WORKSHOP AGENDA

Planning Commission

October 17, 2023 @ 5:30 PM

Planning Commission Report
Meeting: October 17, 2023

SHEET: C1.0

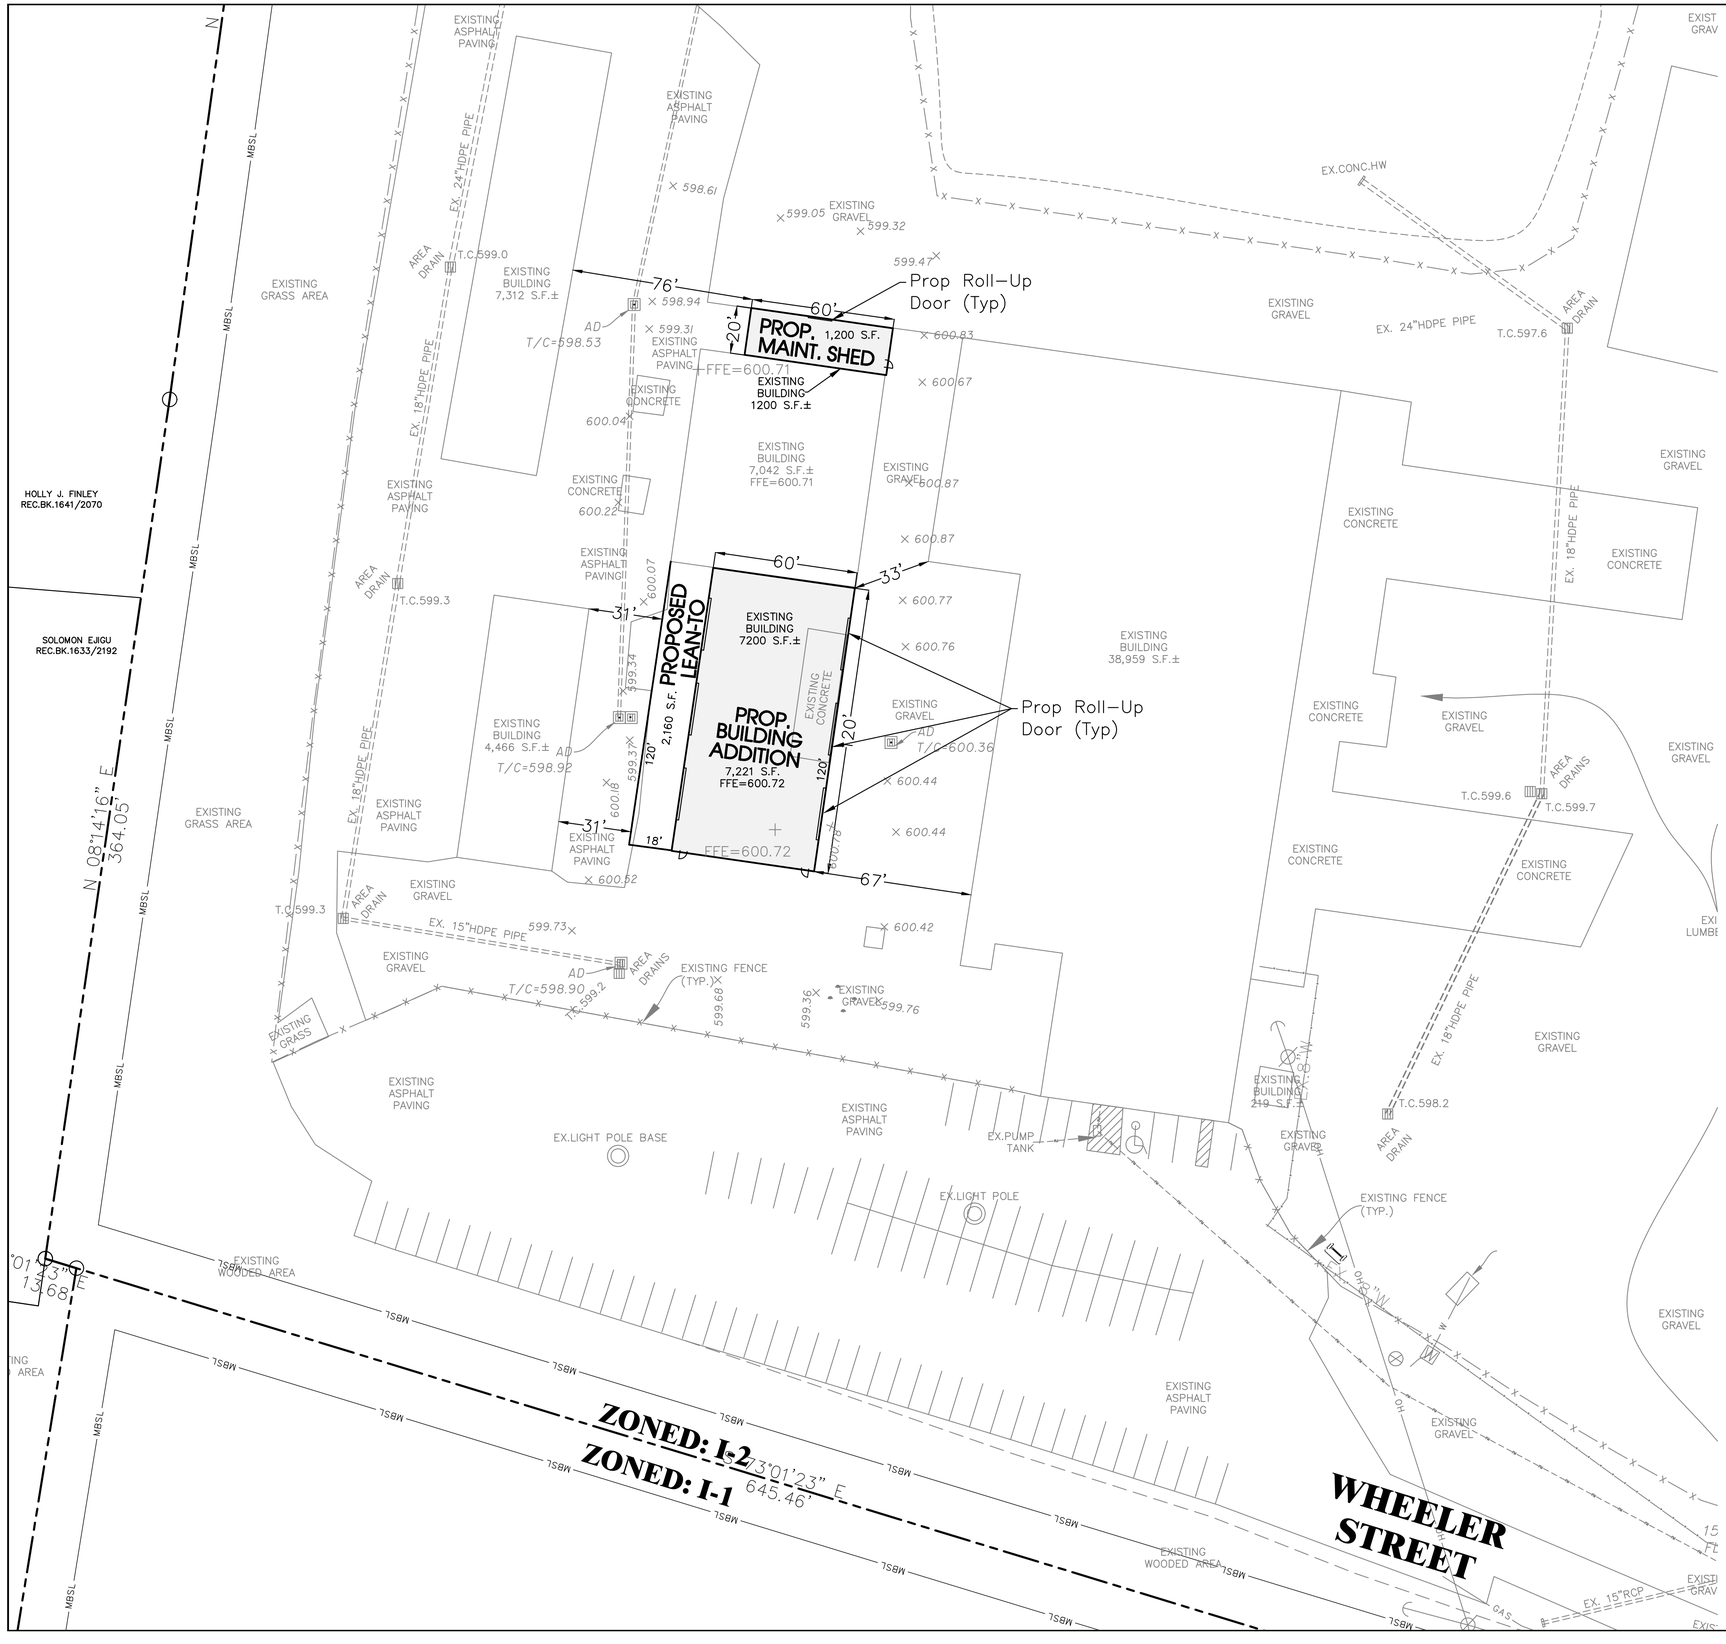
1. Sht C2.0 - Site and Utility Plan, does not show existing utilities.
2. Concept of what is being shown for construction is not clearly identified.
3. It appears 84 Lumber has hired a new engineer (SEC) to prepare plans to install the proposed saw shed previously being prepared by in-house, engineering staff.
4. Engineer needs shall put more work into this drawing set before Utility Engineer can review it.
5. A FH flow test was performed for this job and a water availability letter was prepared for this project. The results of this information is that the project needs an onsite tank for fire flow storage and a fire pump to meet fire flow sprinkler system requirements per previous Fire Sprinkler Engineer. Copies of the fire flow test and water availability letter can be obtained by contacting the Utility Engineer: Scott Tatalovich: 615-287-8739, statalovich@lavergnetn.gov.

1 C101 GRADING & DRAINAGE PLAN
SCALE: 1" = 10'

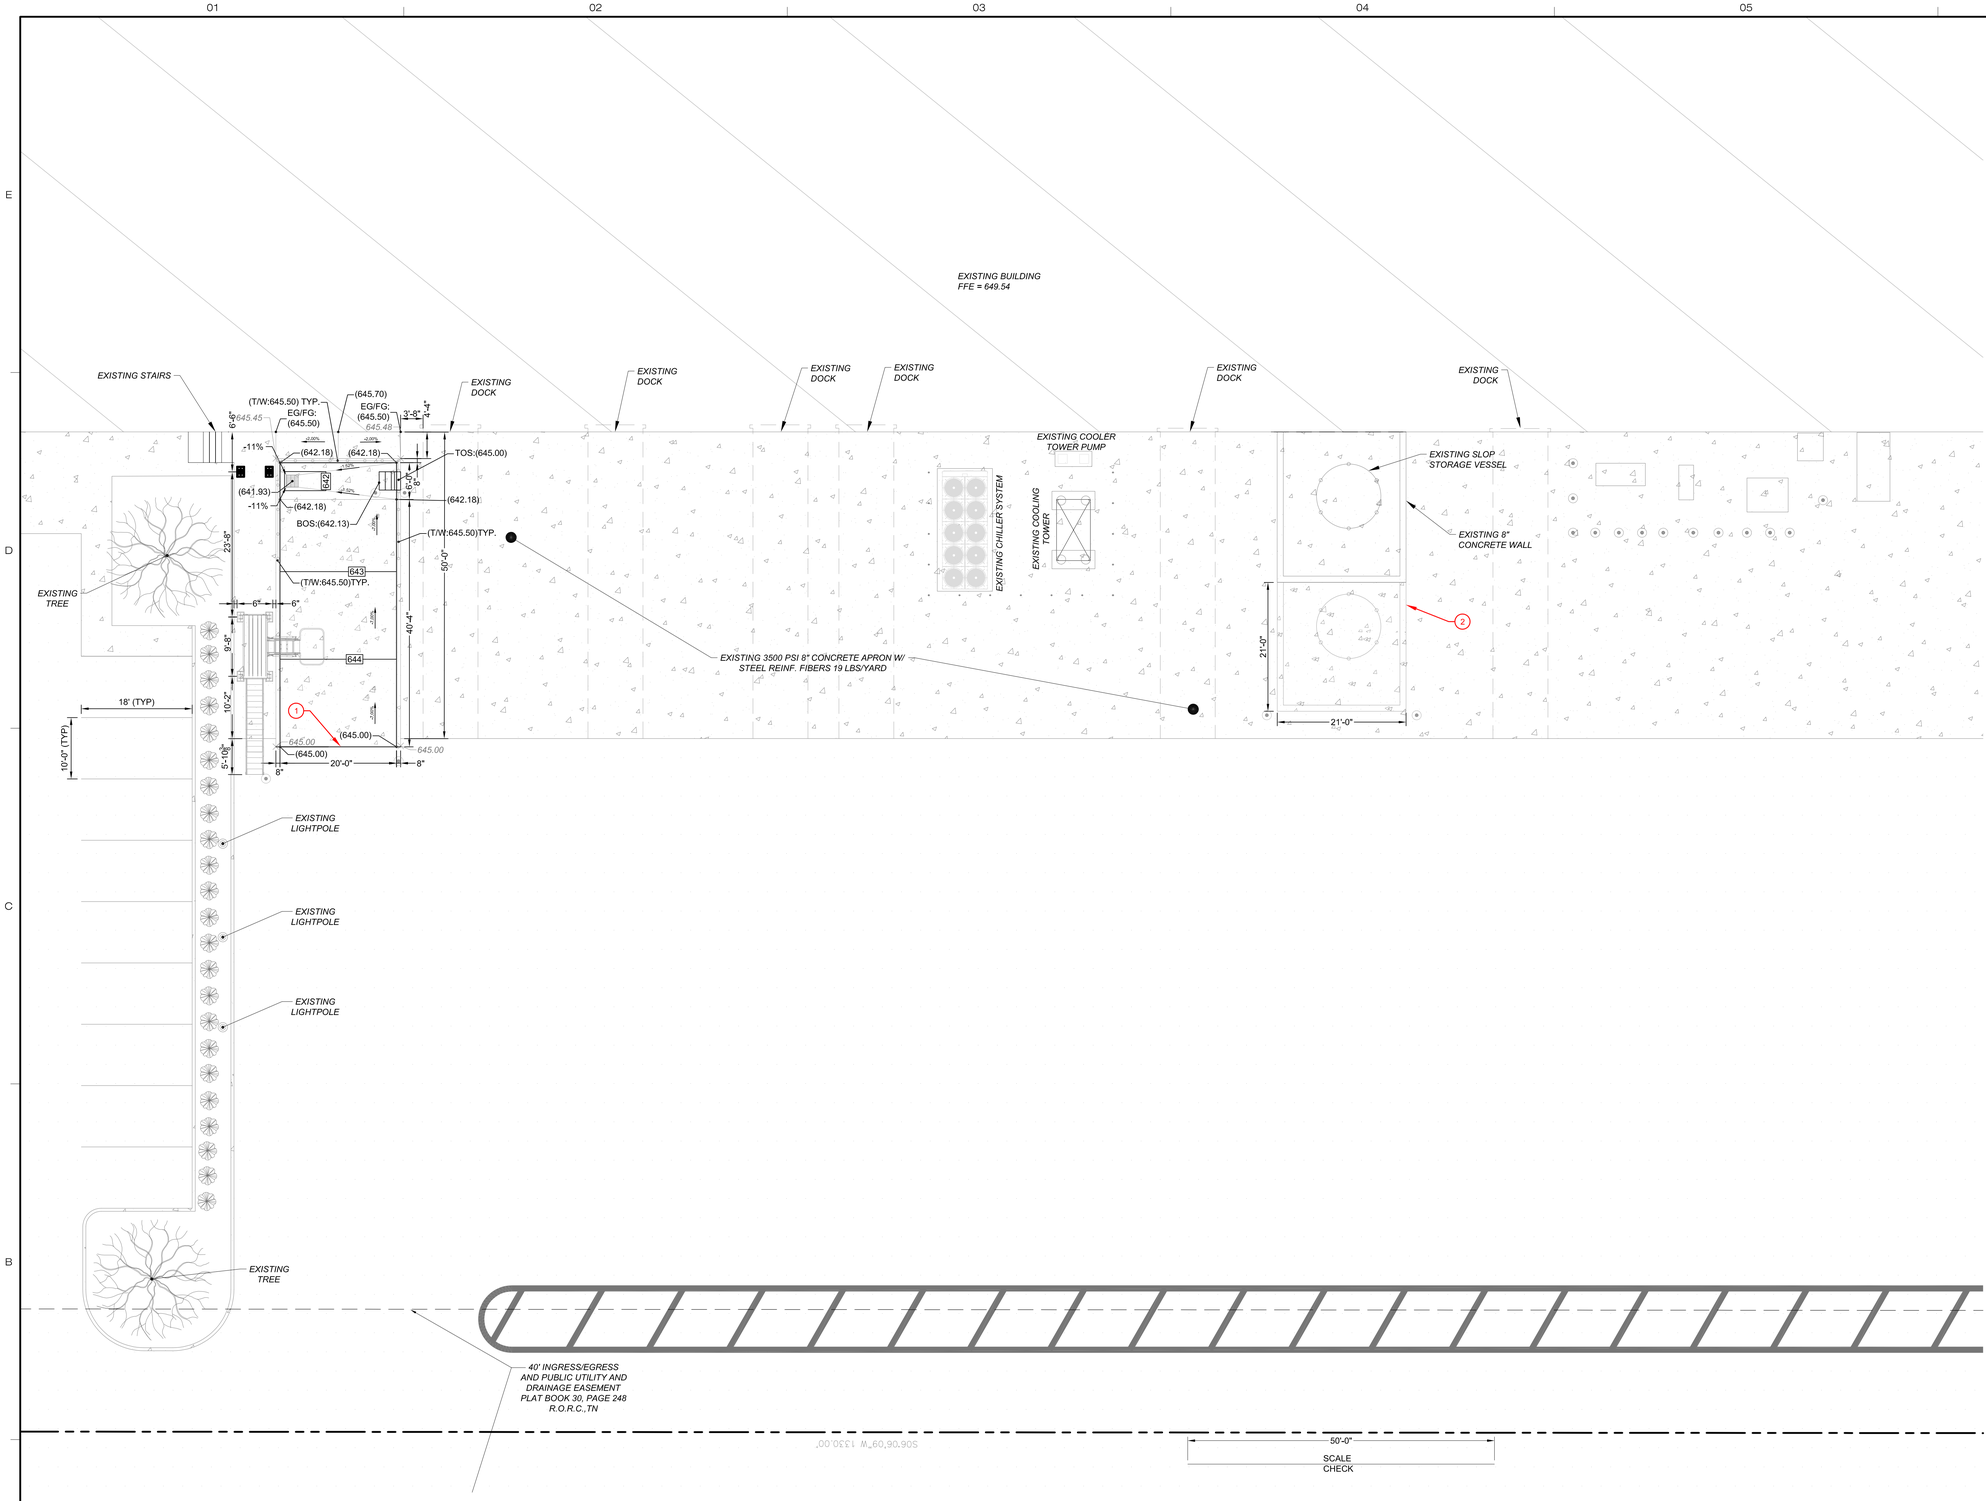
1. (Sheet C102) Show eels downstream (east) of both areas where pavement is being demolished
2. (Sheet C101) Explain how water is removed from sump pit and where it is released.
3. (Sheet C102) Note 2 on this sheet is insufficient. Please denote on the plans where the tire washing will take place.
